SANDY SPRINGS
GEORGIA

P&Z STAFF REPORT

Board of Appeals Meeting, March 4, 2020

Cases: **V19-0031 & V19-0032 – 0 Glenridge Drive (Parcel # 17 0034 LL0096)**
Staff Contact: Madalyn Smith (msmith@sandyspringsga.gov)
Report Date: February 26, 2020

Image 1. Restaurant encroachment into the 25- foot impervious surface setback encroachment highlighted in orange and 50-foot undisturbed natural vegetative buffer encroachment highlighted in red

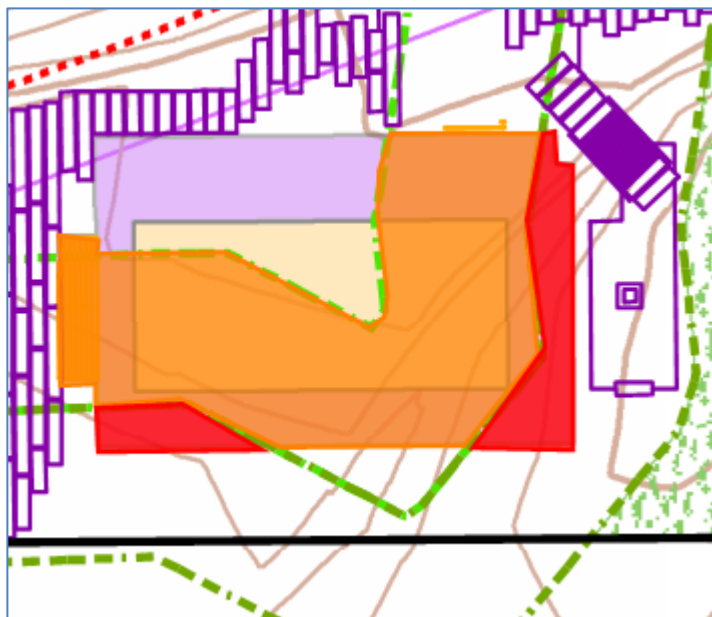
The proposed restaurant would be a raised structure on piers in order to limit ground disturbance. It is proposed that 1,336 square feet of the enclosed building would encroach into the 25-foot setback, in addition to 1,033 square feet of decking. A total of 434 square feet square feet of decking would encroach into the 50-foot buffer.

Image 2. Driveway and footpath encroachment into the buffer and setback highlighted in red, event lawn highlighted in green

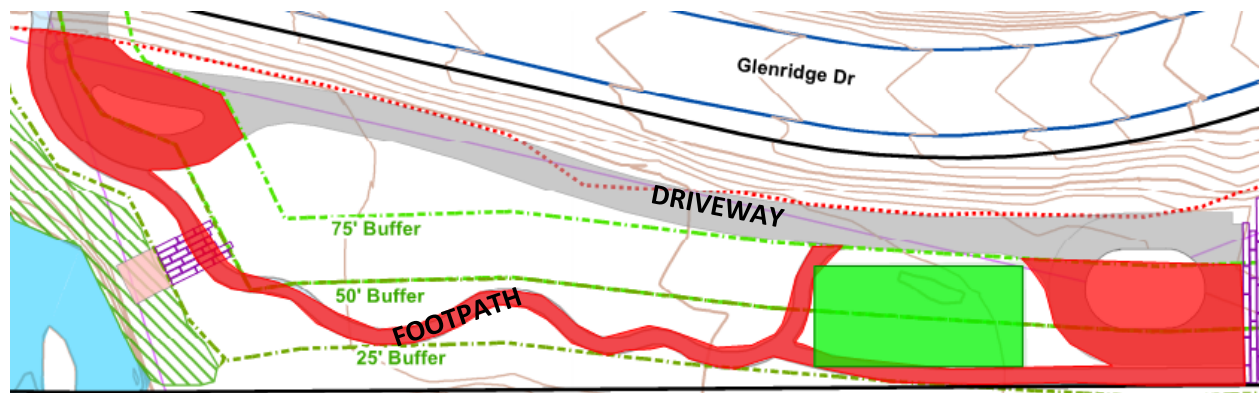
The proposed driveway (4,194 square feet of disturbance) and footpath (3,827 square feet of disturbance) will be constructed of pervious materials. The footpath would provide pedestrian access from the proposed Marsh Creek Trail and the sidewalk along Glenridge Drive, to provide access to the subject property. Additionally, the applicant proposes disturbance for an event lawn in an area previously disturbed by a Fulton County sewer project, which would be graded flat and grassed. There are also decking and pervious areas proposed within the buffer and setback for access to the property from the hotel portion of the site as well as seating/viewing areas throughout.

2. At the time of permitting:
 - a. The applicant must provide pervious material(s) for the driveway and footpath. Materials are determined pervious by the City Engineer and are subject to the approval of the Director of Community Development.

Figure 2.

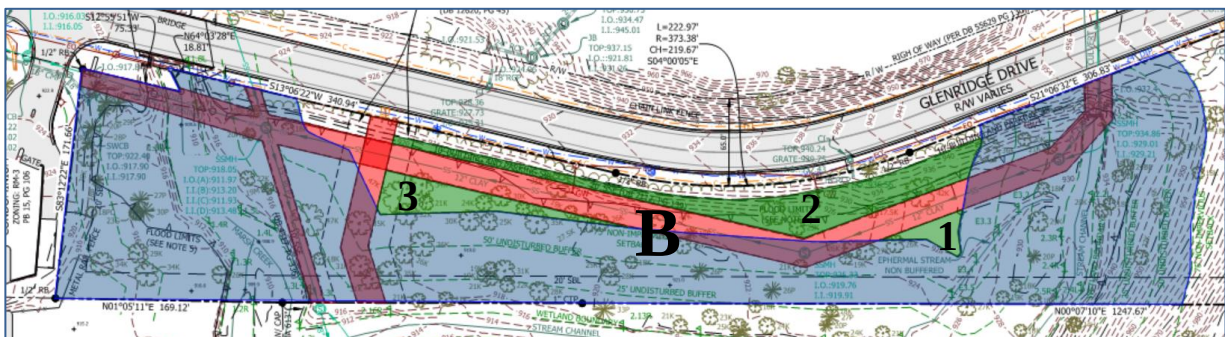
The buildable area of portion "B" is significantly reduced by a Fulton County sanitary sewer easement, though the applicant does have an understanding with Fulton County that would allow them to locate a portion of the proposed deck and driveway over the easement. Figure 2 shows the state waters buffers in blue, the easement in red, and the three (3) separate buildable areas in green, labelled 1-3. Area 1 is ~870 square feet, area 2 is ~6,600 square feet, and area 3 is ~2,150 square feet. The buildable area of portion B is reduced to 9%, or 9,620 square feet, of a 2.6 acres site.

The presence of the buffers does not eliminate the possibility of development on this portion of the property but it is severely limited by the long and narrow shape, two streams, and the sanitary sewer easements.

Figure 5. Proposed Site Plan

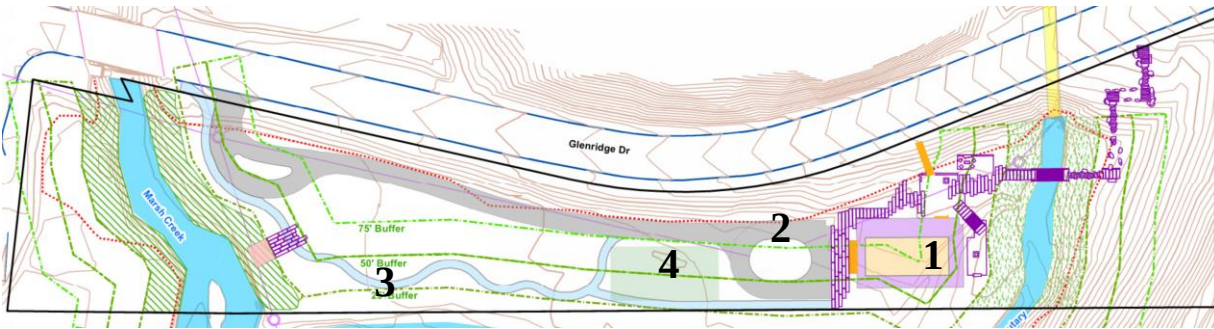
(1) Impervious intrusions for “Biergarten Building” and “Biergarten Deck”*

Buffer/Impervious Setback	Encroachment (square feet)
25' Additional Impervious Surface Setback	2,369
50' City Undisturbed Natural Vegetative Buffer	434
25' State Undisturbed Natural Vegetative Buffer	0
Total	2,903

*In the original Application, the “Biergarten Deck” was improperly labeled as pervious. It is considered impervious surface.

(2) Pervious intrusions for driveway*

Buffer/Impervious Setback	Encroachment (square feet)
25' Impervious Setback	2,500
50' City Undisturbed Buffer	1,694
25' State Undisturbed Buffer	0
Total	4,194

(3) Pervious intrusions for footpath

Buffer/Impervious Setback	Encroachment (square feet)
25' Impervious Setback	240
50' City Undisturbed Buffer	3,587
25' State Undisturbed Buffer	0
Total	3,827

(4) Pervious intrusions for event lawn

Buffer/Impervious Setback	Encroachment (square feet)
25' Impervious Setback	1,682
50' City Undisturbed Buffer	1,520
25' State Undisturbed Buffer	0
Total	3,202

3. The proposed deck is listed as Pervious Surface in the application. The applicant should provide sufficient plans, detail and supporting data, as determined by the Director, to support classification of the deck as pervious surfacing at the time of permitting.

4. The proposed vehicular driveways and pedestrian walkways are shown on the plan as Pervious Surfaces. The applicant should provide sufficient plans, details and supporting data, as determined by the Director that the proposed surfaces will provide infiltration equivalent to natural pervious surfaces at the time of permitting,

1. The intrusion be limited to and substantially similar to that shown in “Figure 1: Proposed Site Plan” prepared by Kimley Horn and “BIERGARTEN SITE PLAN – D.C. – 6.1.2A – PREFERRED PLAN” prepared by Cooper Carry; both received on February 14, 2020.

Figure 6. Alternate 1

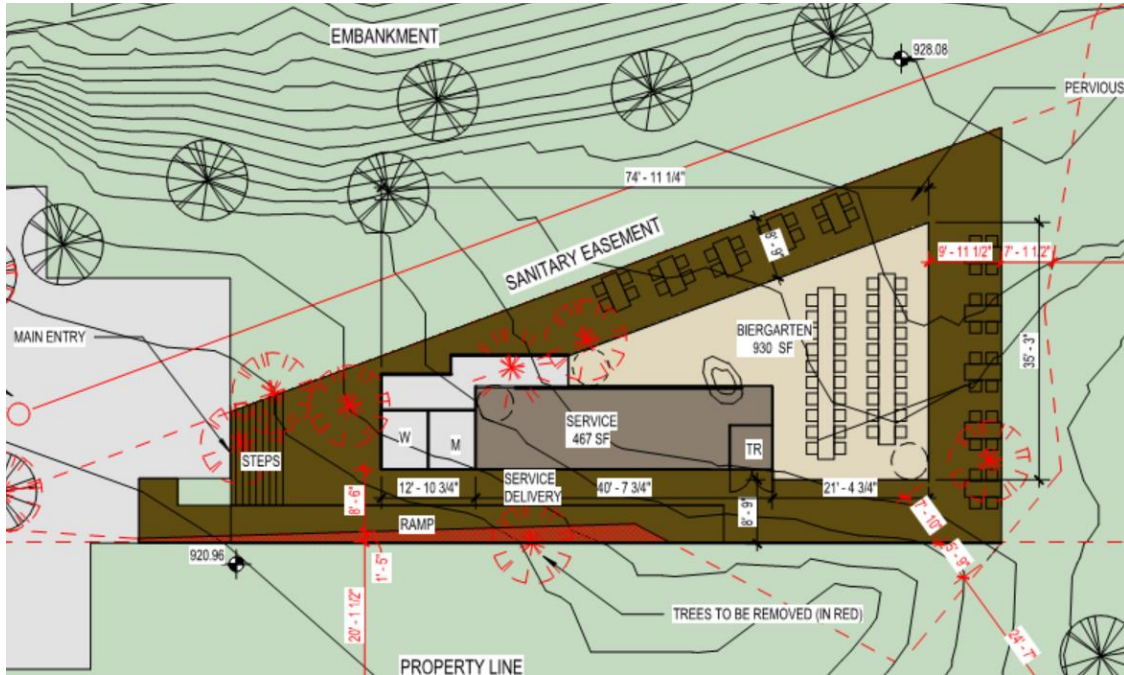
Alternate 1 shows no intrusion within the 50-foot undisturbed natural vegetative buffer, but the building would not be functional.

Alternate 1 does not appear viable due to the awkward shape of the building. Alternatives 2 and 3 do not adequately protect the buffers and the 25-foot additional impervious surface setback, and thus are not the minimal relief necessary.

Figure 7. Alternate 2

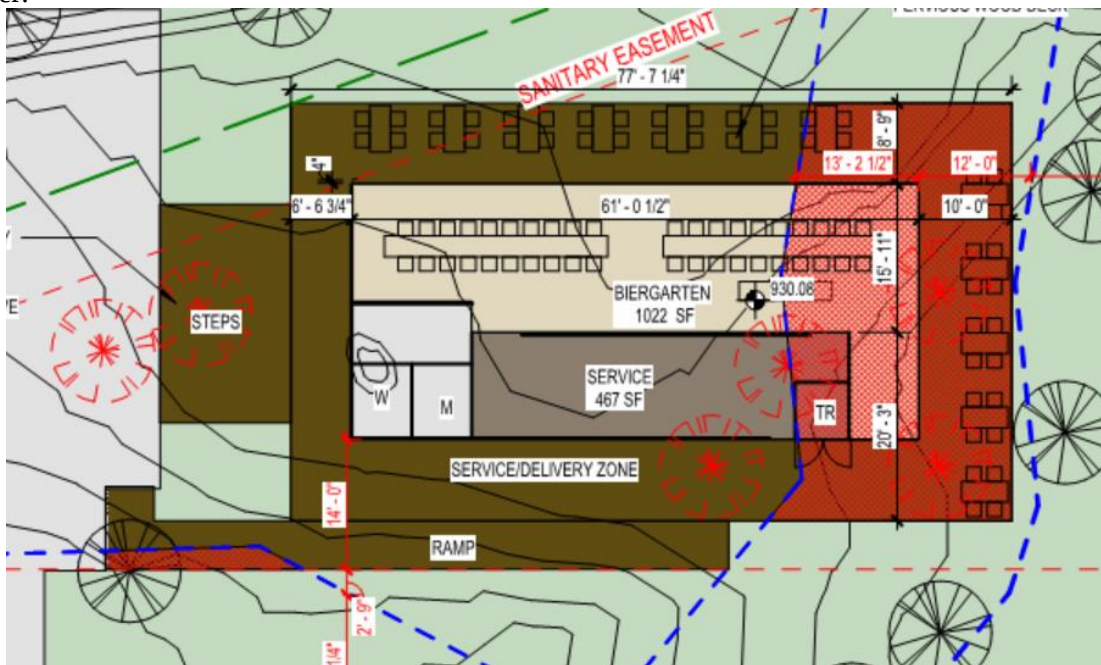
Alternate 2 proposes 1,104 square feet of encroachment into the 50-foot undisturbed natural vegetative buffer.

Figure 8. Alternate 3

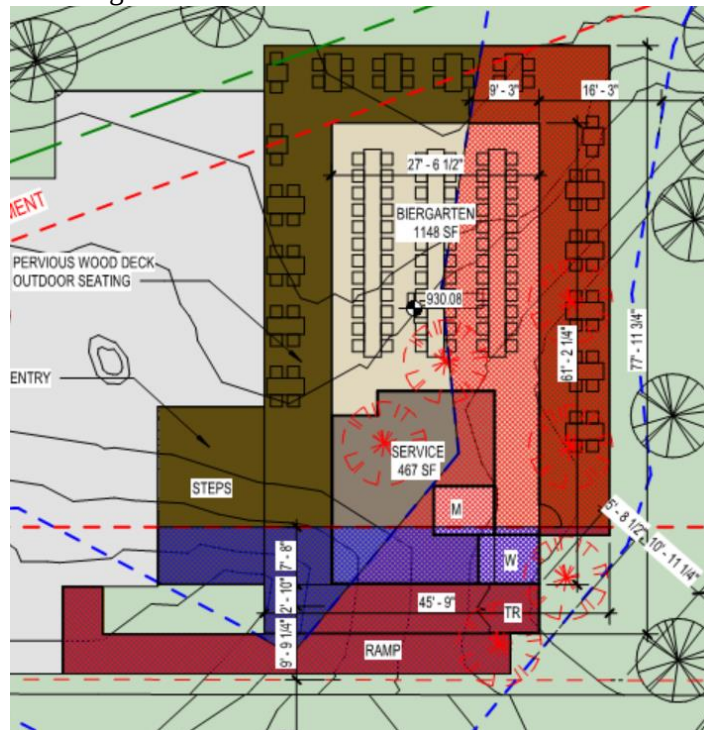
Alternate 3, the applicant's previous preferred request, shows 2,021 square feet of disturbance within the 50-foot undisturbed natural vegetative buffer.

Figure 9. Proposed Plan

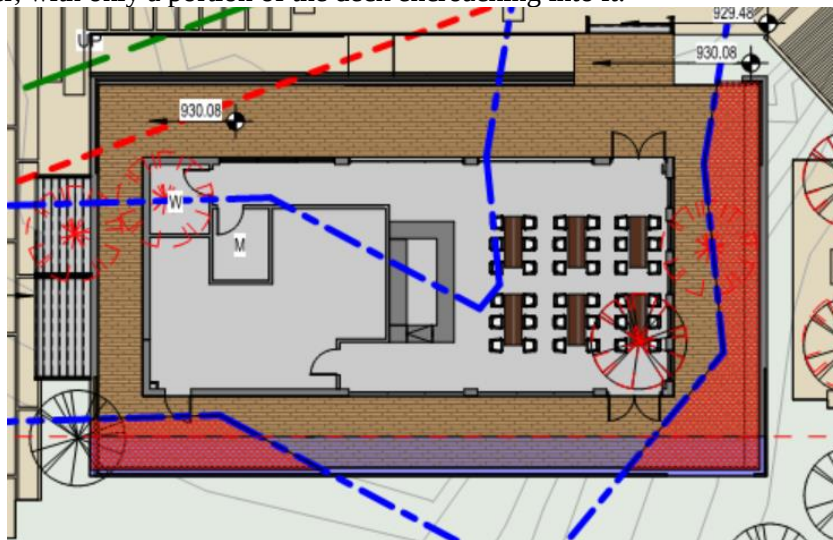
The current plan the applicant has proposed, limits intrusion into the 50-foot undisturbed natural vegetative buffer, with only a portion of the deck encroaching into it.
